MFN 07-221

Docket No. 52-010

**Subject: Response to Portion of NRC Request for Additional Information Letters, Nos. 77 and 90 – Safety Analysis – RAI Numbers 15.0-20 through 15.0-23, 15.0-25 and 15.4-21**

**Response to Portion of NRC Request for  
Additional Information Letter No. 90  
Related to ESBWR Design Certification Application**

Figure 15.0-20(A)-1 TBV Related Systems

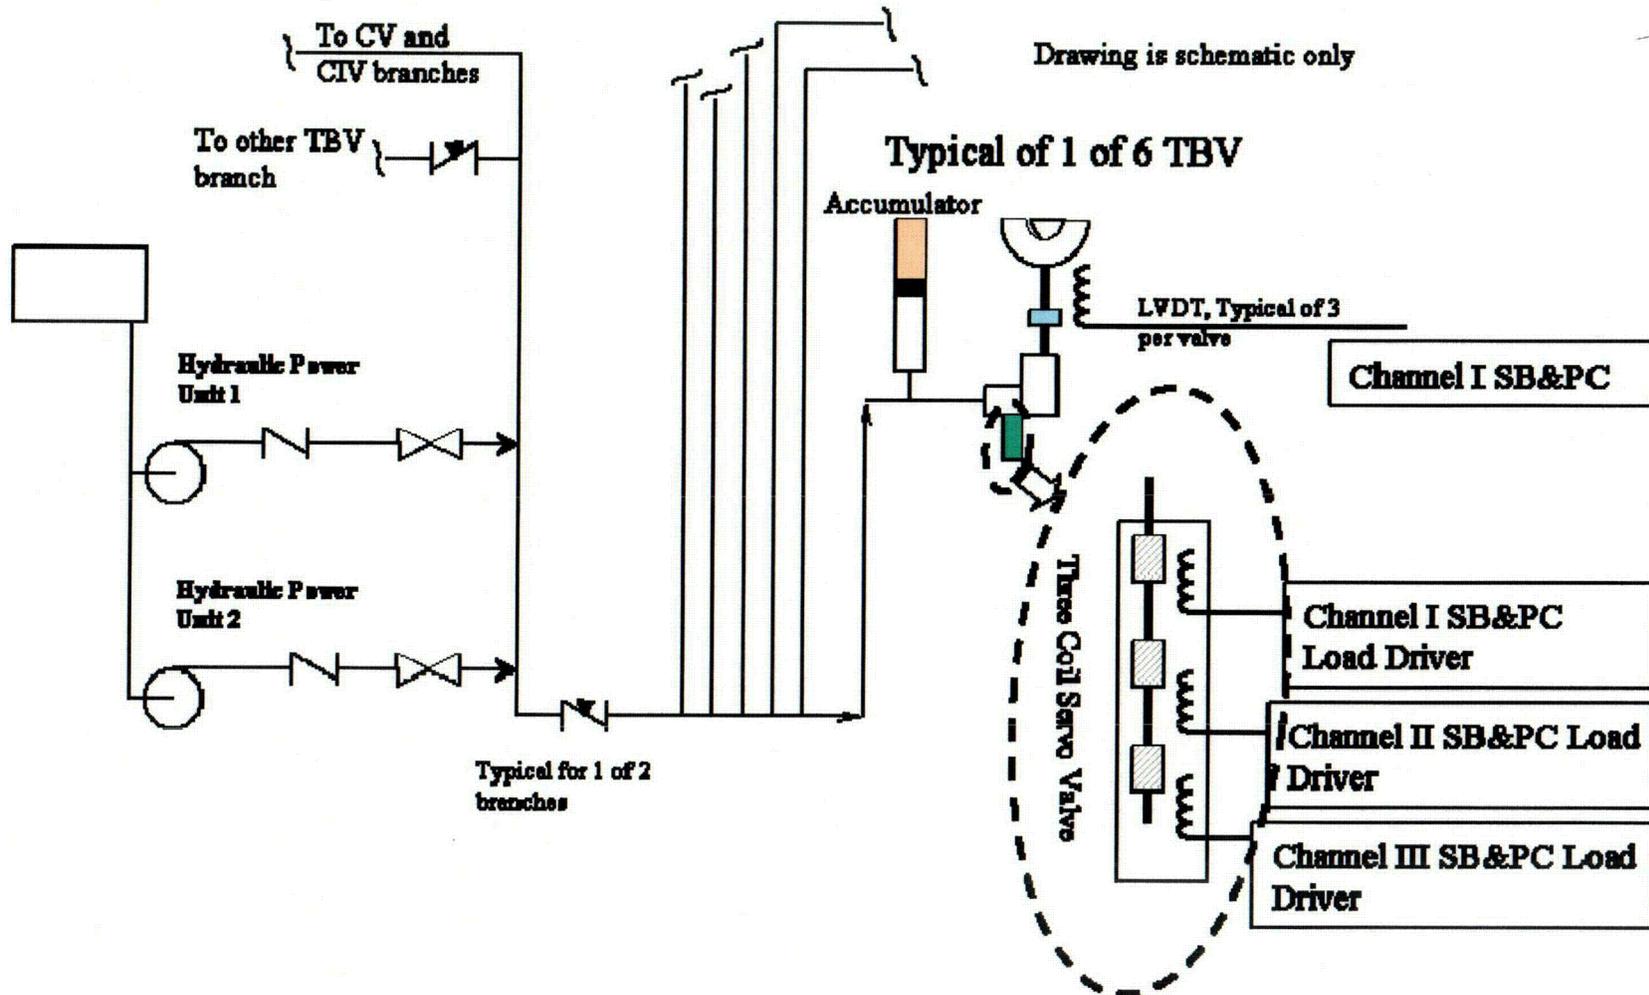
*(A) A simplified process flow diagram of the Turbine Bypass System and associated fault tree that models the failure of seven or more of the 12 available Turbine Bypass Valves (TBVs) on demand. This information should be readily available since it is part of the information needed to respond to RAI 19.1.0-55 of the PRA (basic event N21-SYS-FF-BYPASS). Please include discussion of assumptions made about the failure of TBVs and support systems (e.g., AC power, I&C, compressed air, and individual valve accumulators).*

Figure 15.0-20(A)-1 is a simplified schematic of the process flow diagram for the Turbine Bypass System (TBS).

The hydraulic system for the TBVs consists of the subsystems and components identified on Figure 15.0-20(A)-1. The critical items to note are the following:

Each TBV is independently controlled and has its own accumulator. (See Item (A) and RAI Figure 15.20(A)-1).

Figure 15.0-21-1 Loss of Feedwater Heating SCRRI & SRI

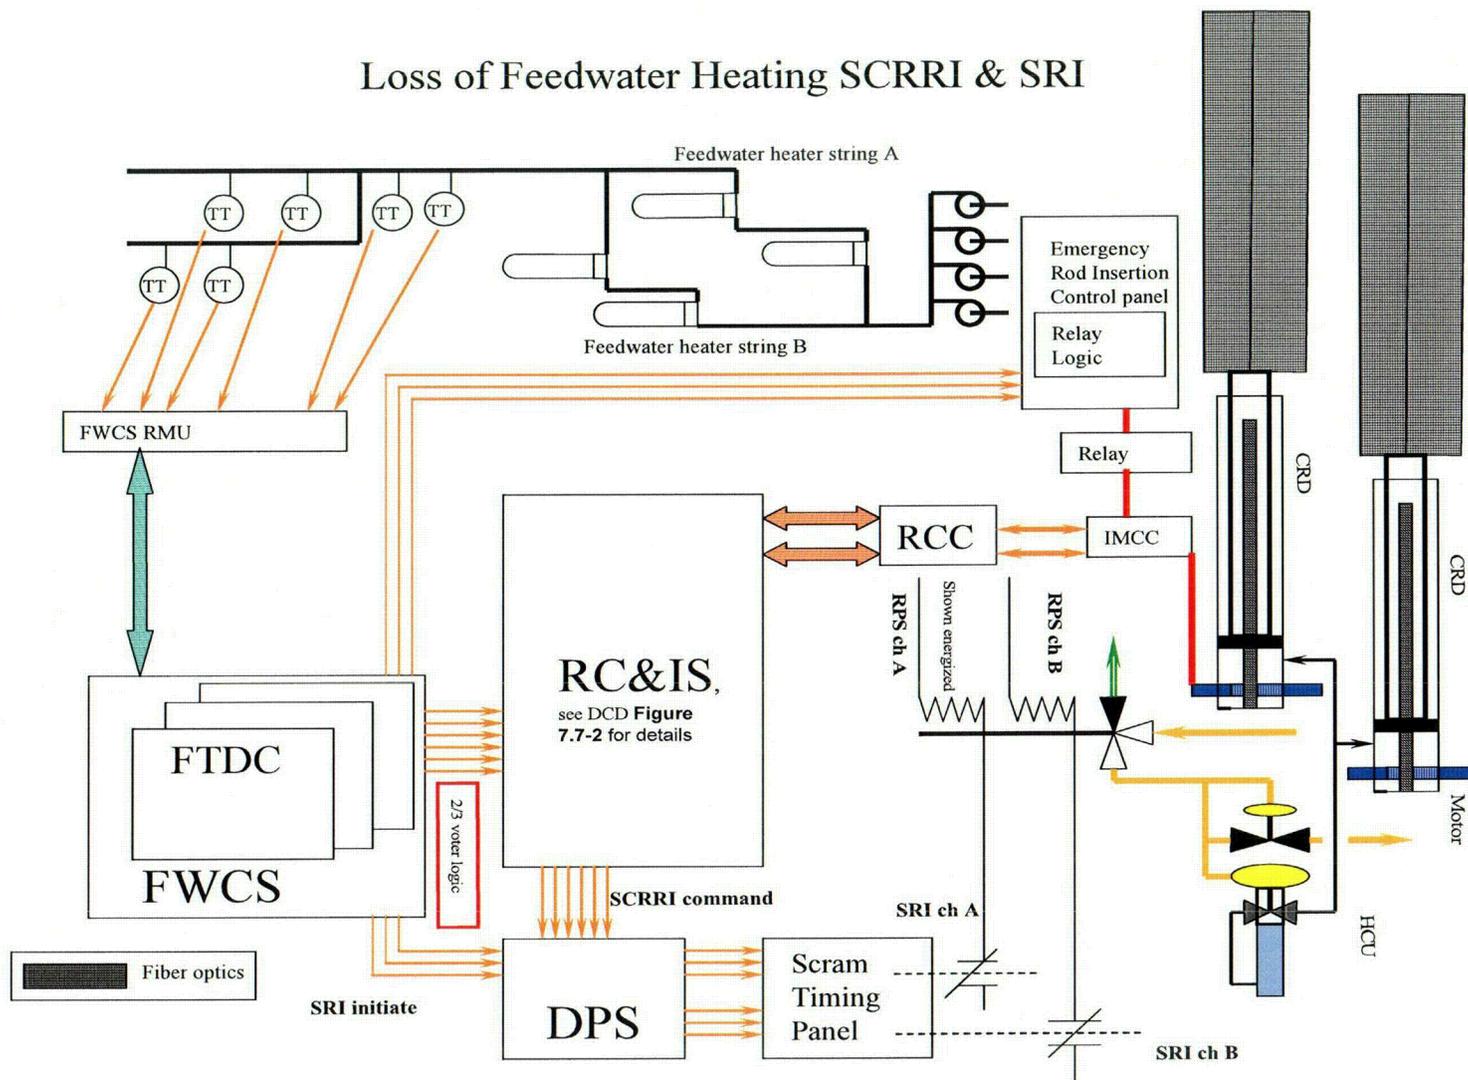
*(B) Additional information is needed for the staff to understand how the I&C systems were modeled in assessing the frequency of the "Loss of Feedwater Heating with Failure of Selected Control Rod Run-In" event. A simplified I&C block diagram, showing the processing of signals, important elements and design features (e.g., redundancy and diversity) and assumptions (e.g., independence and separation) for both automatic and manual actuation of components, would be very helpful. Such a simplified I&C block diagram could help answer staff questions, such as the following:*

A simplified I&C diagram for the loss of FW heating with failure of selected control rod run-in is shown in Figure 15.0-21-1.

B(1) The FWCS can be postulated to have a latent failure that defeats its ability to sense the loss of FW heating. This potential common cause failure is added to the failure modes assessed in the RAI response to 15.0-25(B).

B(2) The treatment of the primary and backup signals is included in the revised calculation presented in response to RAI 15.0-25(B). No operator action is required for the hard-wired signals.

FIGURE 15.0-23(B)-1 SRV OVERPRESSURIZATION

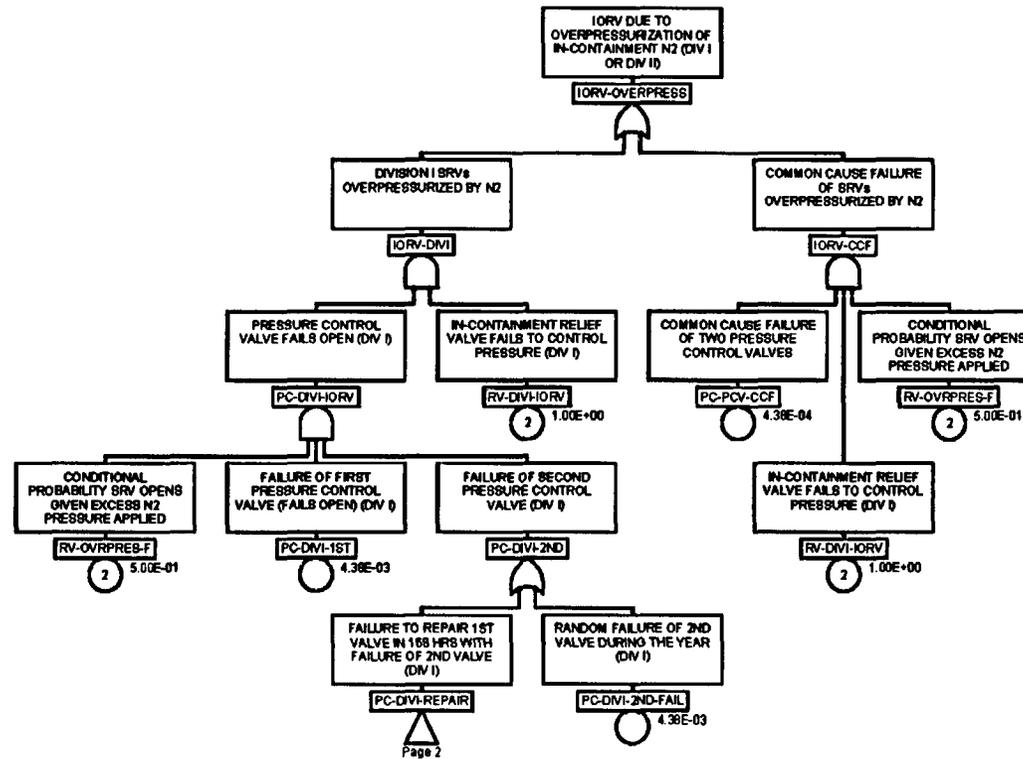
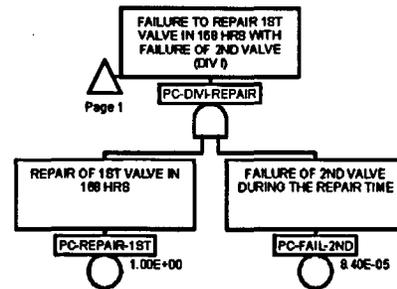
*(B) The probability of excess Nitrogen pressure leading to an IORV was estimated to be 1.5E-6 per year. This value is based on a proposed COL action item to confirm that no single failure in the nitrogen system can lead to IORV and the assumption of independence of failures. Please justify the assumption that no CCFs of the nitrogen supply system can lead to an IORV event. Otherwise assess the CCF contribution and revise the related probability. In addition, the assumed repair time of one week for a nitrogen supply system valve may not be a conservative value and needs to be justified in terms of requirements (e.g., Technical Specifications).*

Figure 15.0-23(B)-1 summarizes the failure modes that may lead to SRV overpressurization including common cause failures.

The revised total failure probability for SRV opening due to excess nitrogen pressure including the CCF is 2.29E-04/yr.
